DESCRIPTION OF WORK: 1. REMODEL FORMER MEN'S LOCKER, SHOWER, SUNA, AND RESTROOM FACILITIES FOR USE BY WOMEN TO GAIN A DIGNITY BETWEEN MEN'S & WOMEN'S FACILITIES. 2. INSTALL A NEW ARTICLE IS ELEVATOR TO PROVIDE A PATH OF TRAVEL TO THE REMODEL AREA. 3. ALTER & / OR REMODEL OTHER FEATURES, TO PROVIDE ACCESS, INCLUDING MEN'S RESTROOM, STAIRWAYS, DOORS, AND SIGNAGE.

DOLPHIN CLUB
S WIMMING & BOATING
SAN FRANCISCO
ORGANIZED 1977
LOCKER ROOM & SHOWER EXPANSION

SITE/ROOF
PLAN; GENERAL
INFORMATION

SECOND FLOOR - EXIST'G./DEMO. & PROPOSED

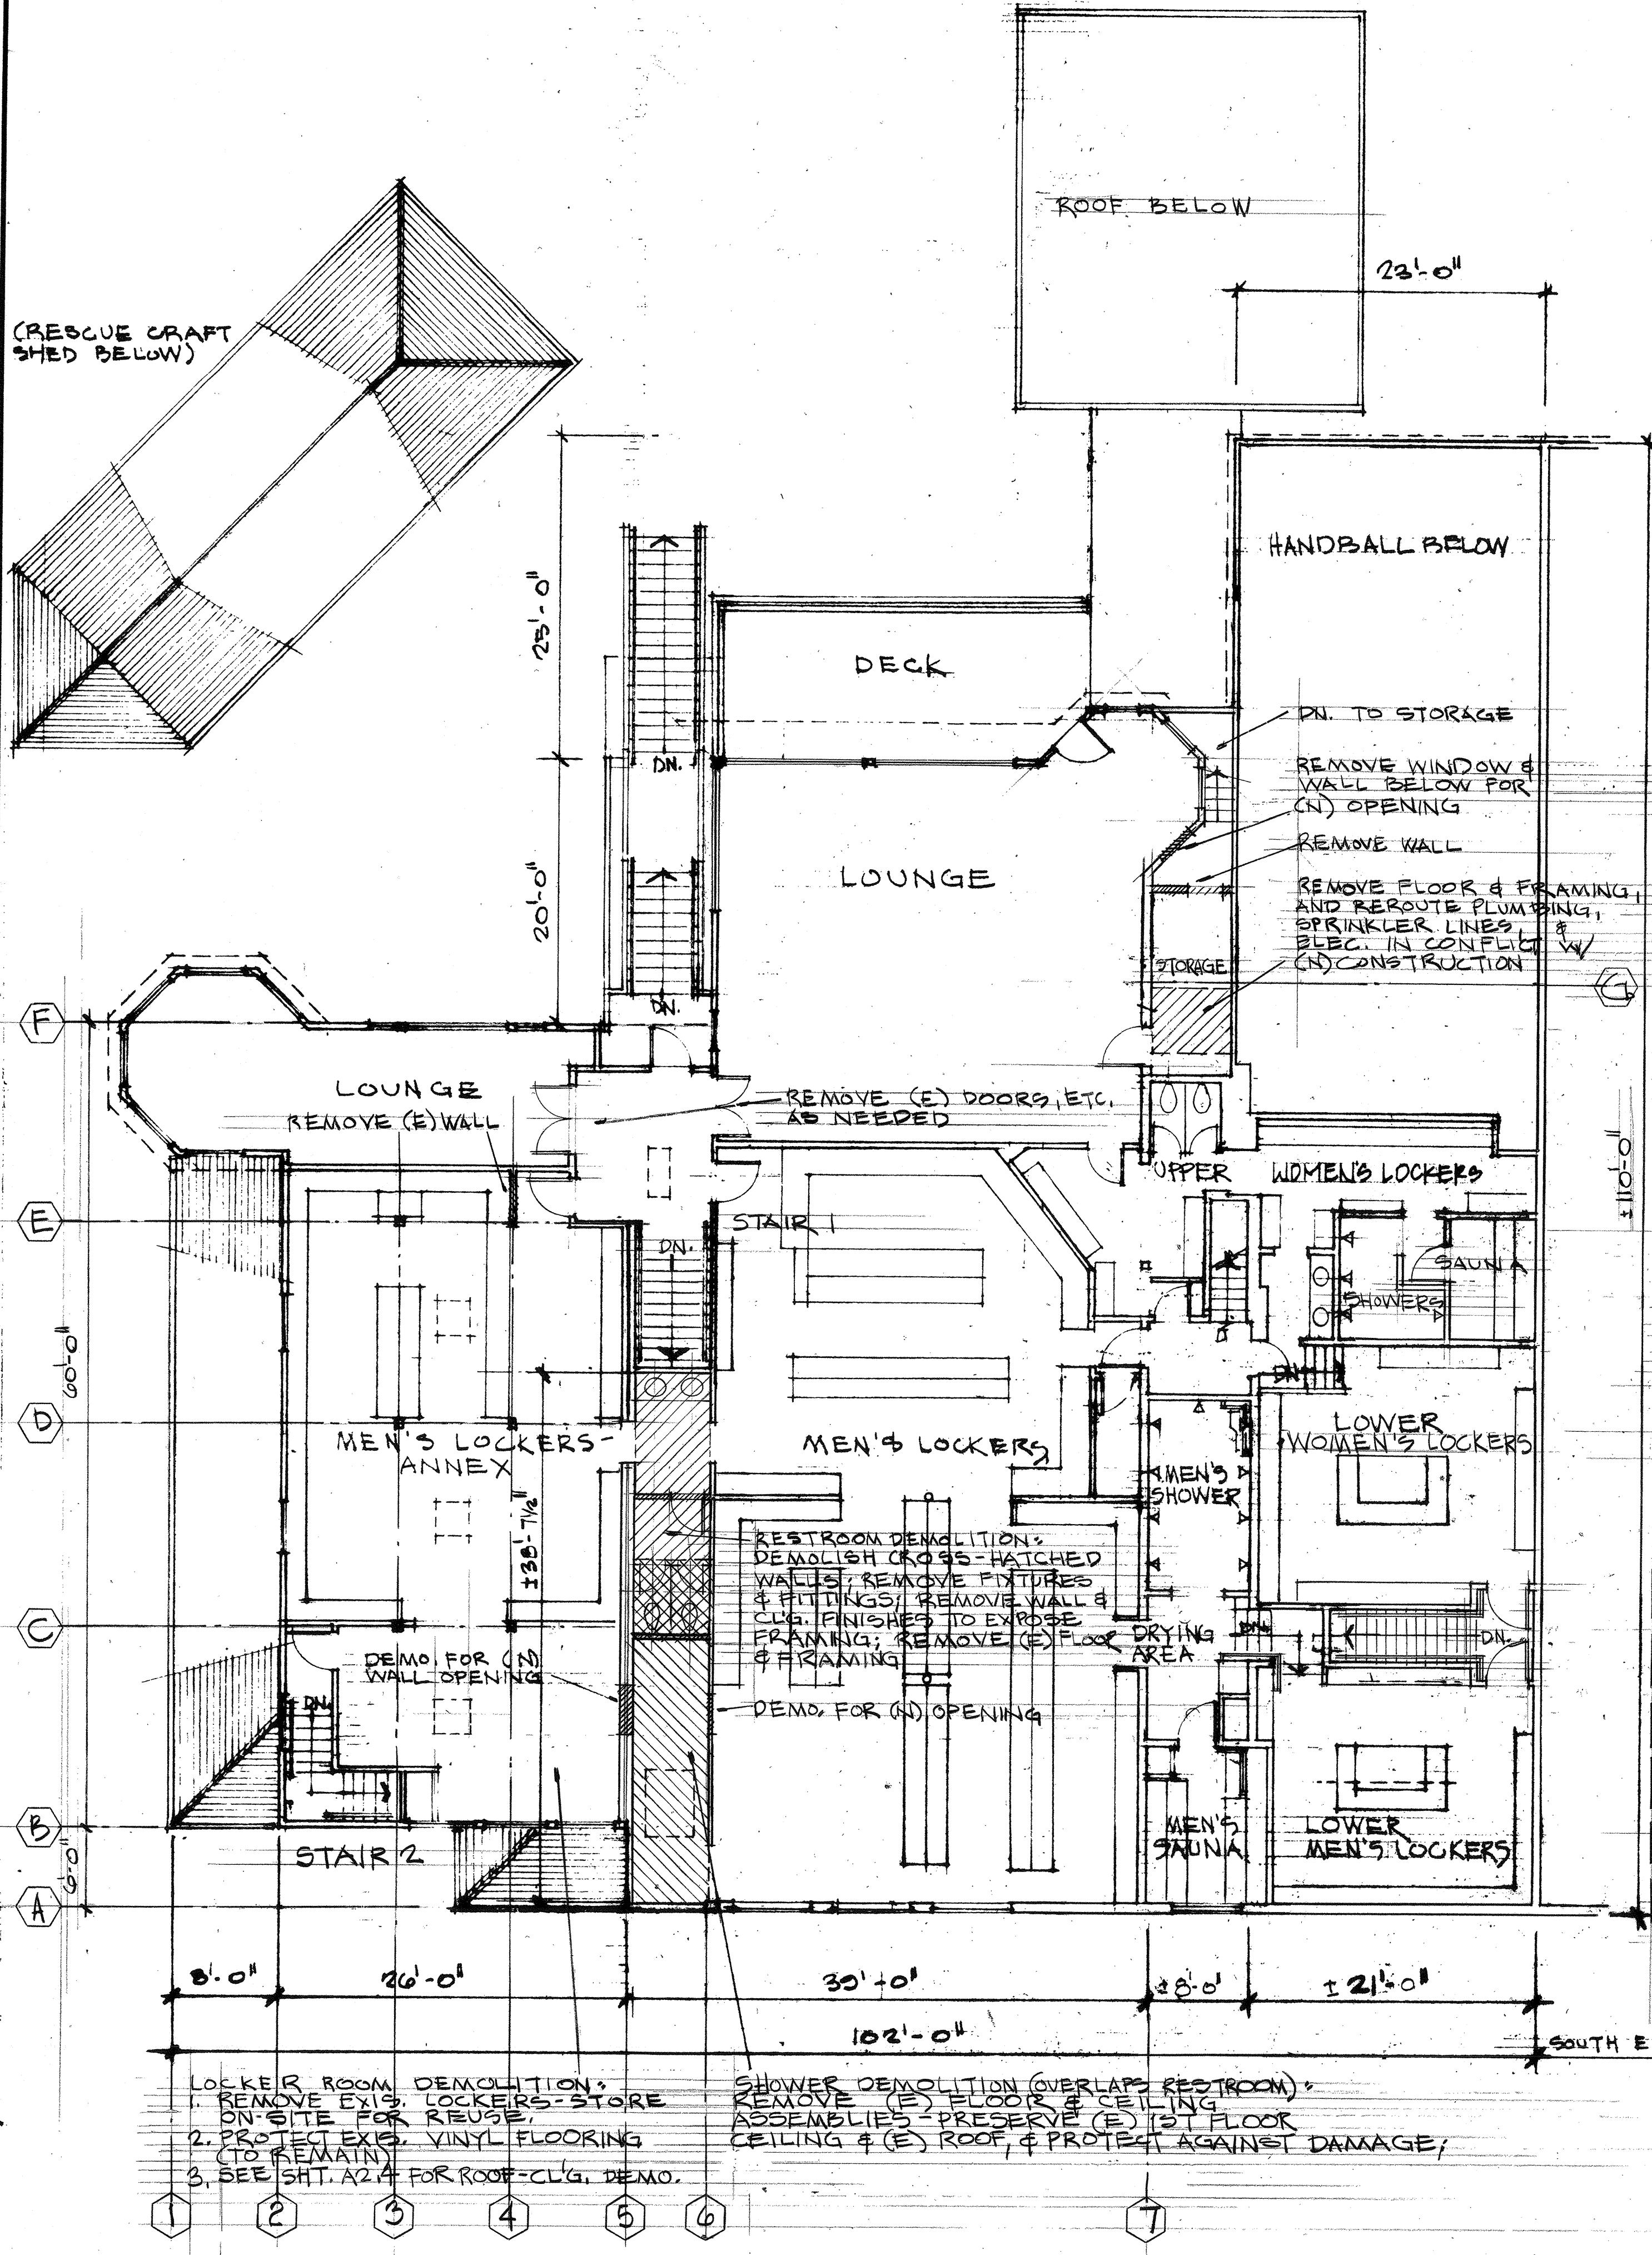
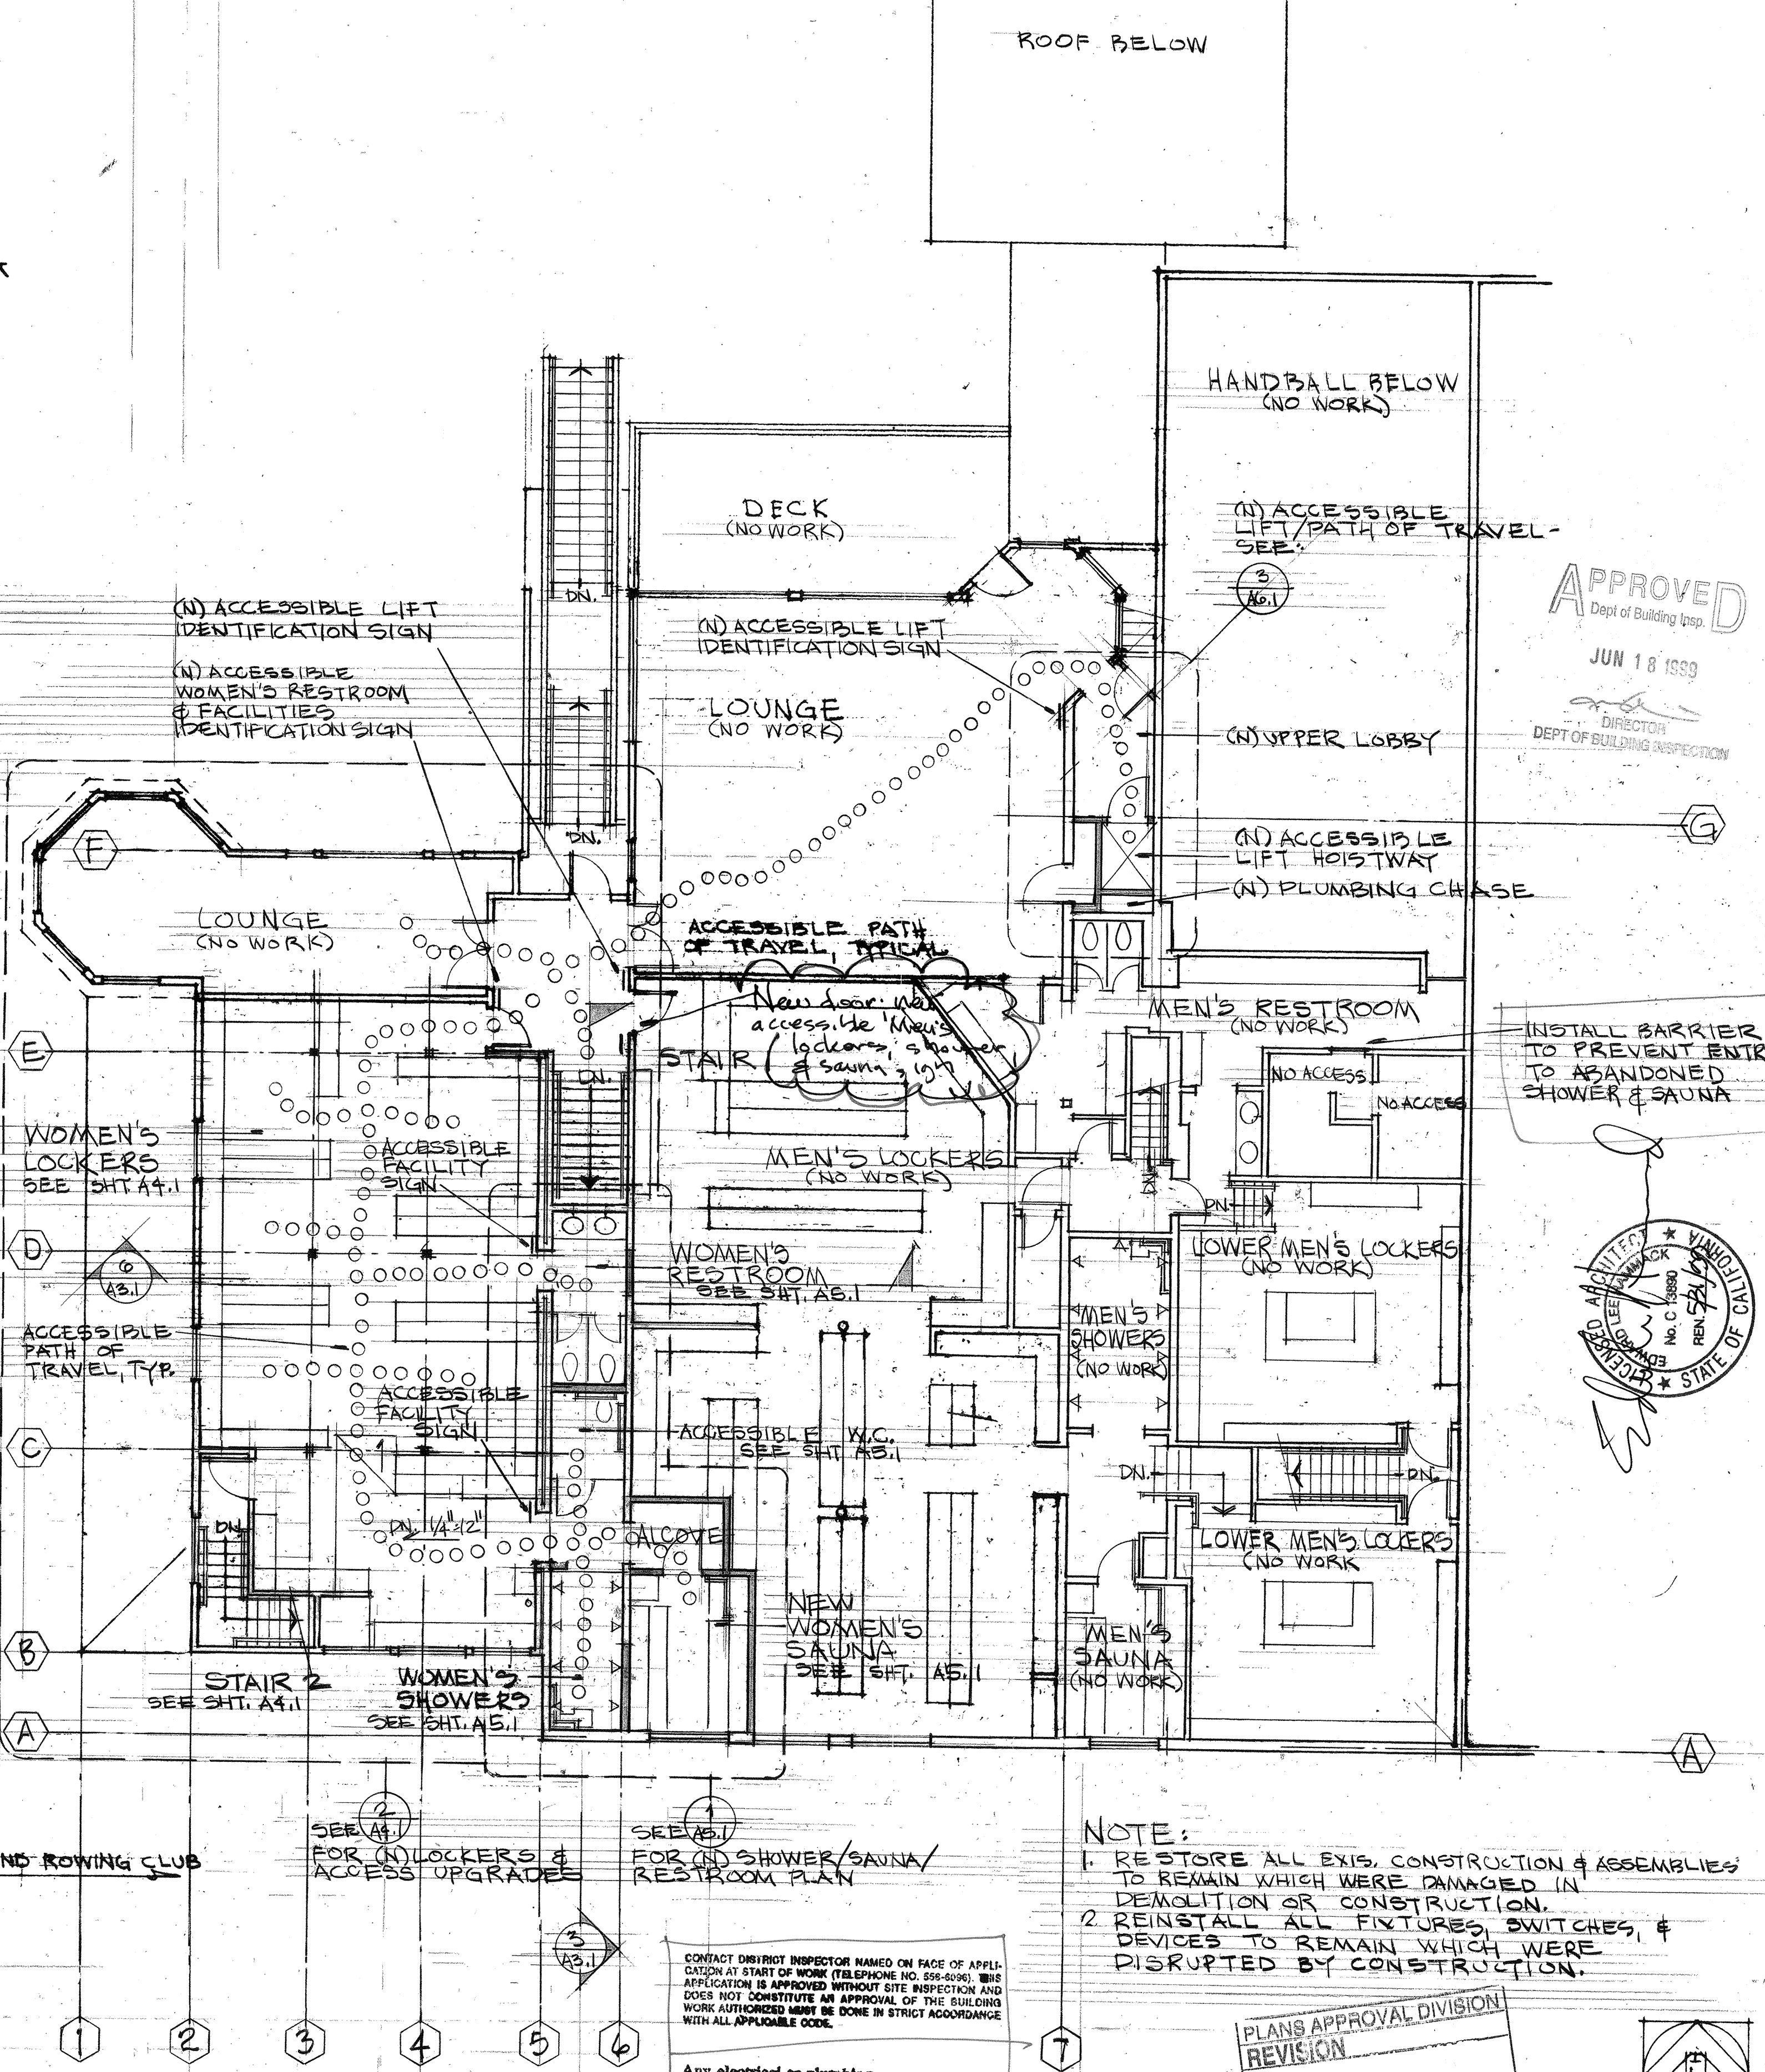
REVISIONS:
 1. ARTICLE 13 ACCESSIBLE LIFT ADDED.
 2. WOMEN'S LOCKER ROOM LAYOUT REVISED.
 3. SHEET NUMBER CHANGED.
